RE: 10-ZN-2021: Rezoning @ 13647 N. 87th Street (Key Code 928V1)

Ms. McClay,
Please refer to my responses to your 1st review comments as stated below.

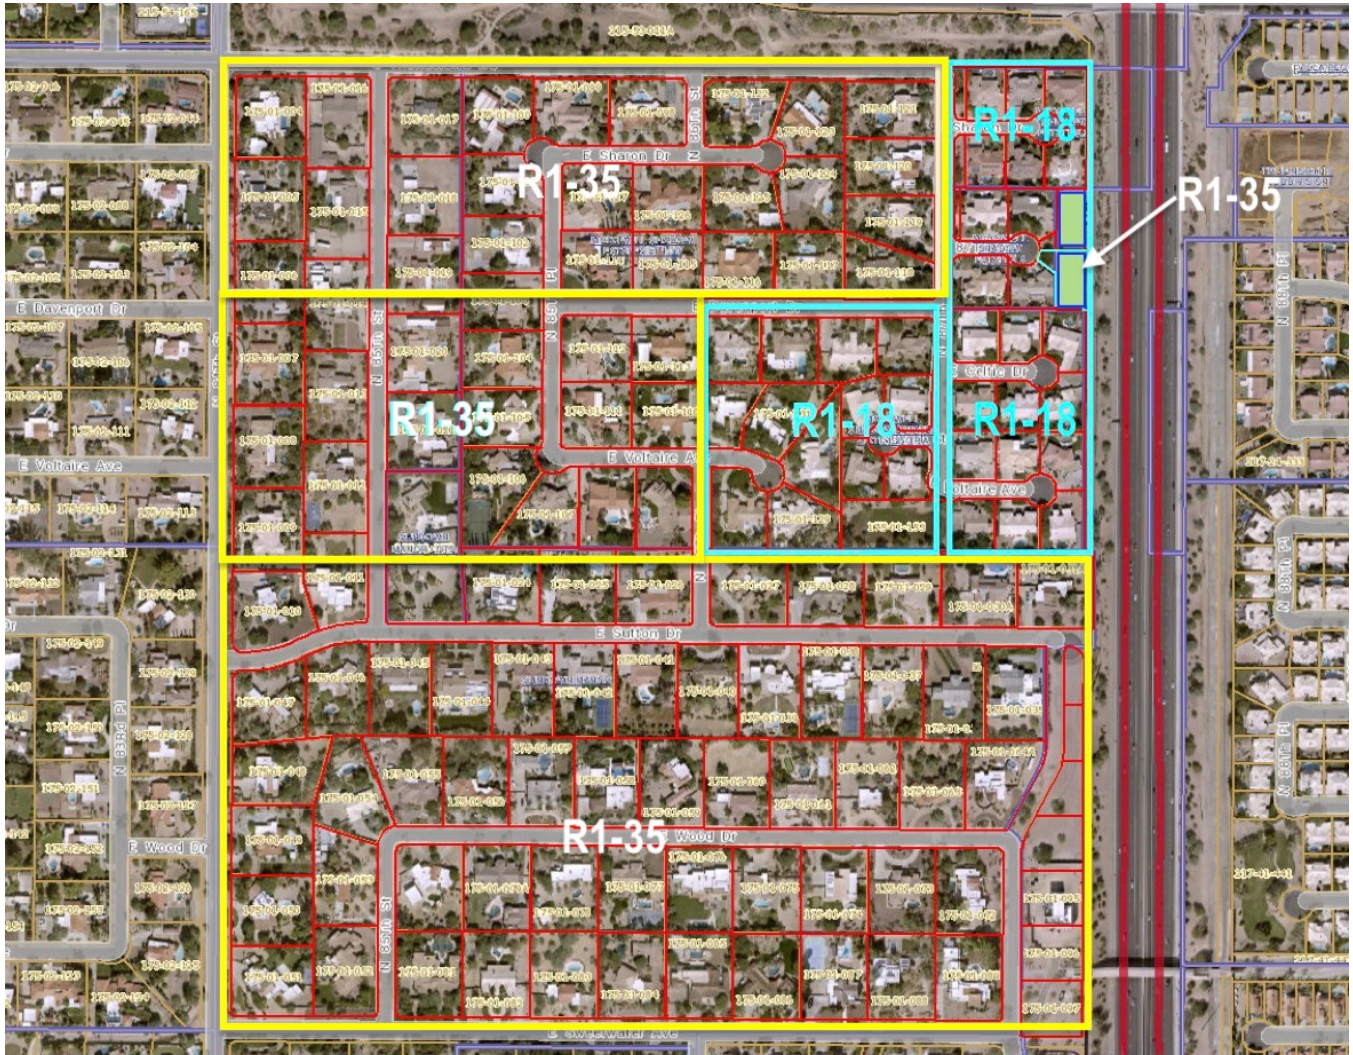
- The narrative states that the proposal is within the density prescribed for this area. Please provide graphic and narrative response that notates surrounding densities within the context area south of Thunderbird Road, east of 84th Street, north of Sweetwater, and east of Loop 101.*

- **Response:** The proposed home is well positioned within the density prescribed in the neighborhood. The lot size is 15,700 sf adjoining the subdivision zone: R1-18. Please refer to the data and areal map as following:

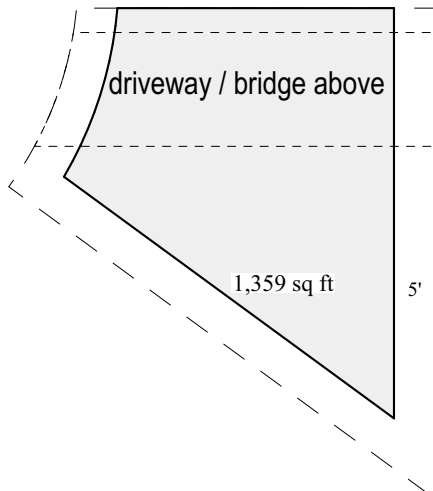
8. *Please be advised the ADOT remnant property from the construction of Loop 101 right-of-way is a legal non-conforming parcel with the R1-35 zoning (as shown below).*
 - **Response:** please refer Mr. Richert's letter

Water retention area at cul-de-sac

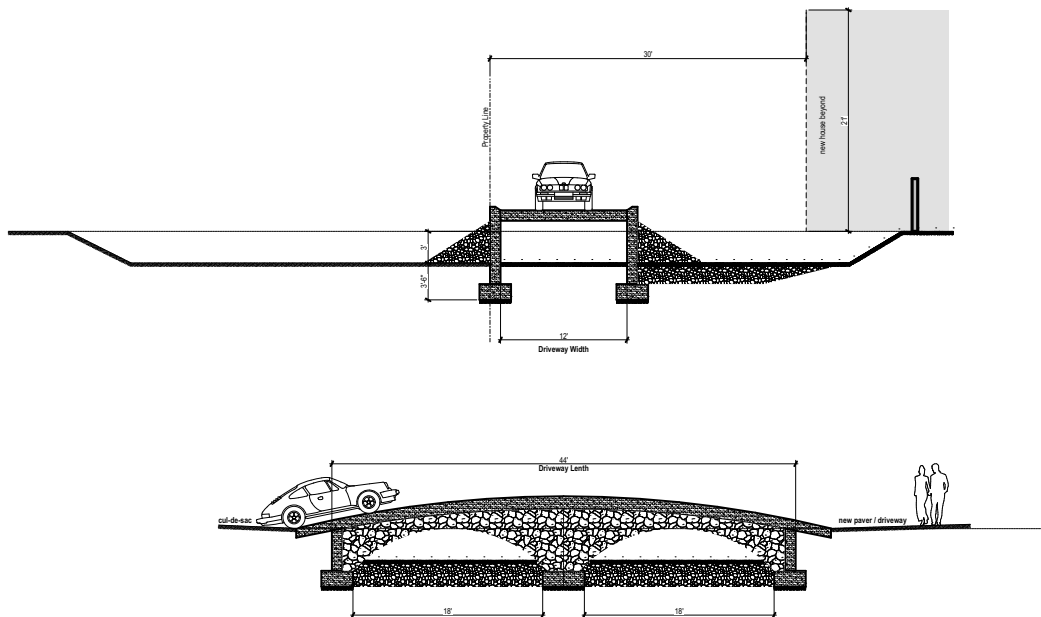
9. *Please submit the revised Drainage Report and Grading and Drainage Plan with the rest of the resubmittal material identified in Attachment A.*
 - **Response:** Instead of altering the existing water retention area, I propose to construct a bridge over the retention area. The driveway will eliminate the need for the grading and drainage study. The existing retention area will be maintained as is currently configured. I will also further improved retention capacity by removing undesirable overgrown vegetation and landscape debris. (Refer to the attached photos) During the clearing work, I will re-grade and replace riprap to increase the water percolation. New bridge will minimize any adverse impact on the retention area. The existing retention surface area is 1,359 sf, as shown below. This retention area will be graded an average of 3 ft in depth including 50% slope along the existing boundary. The total retention capacity shall be approximately 5,502 cf in total.
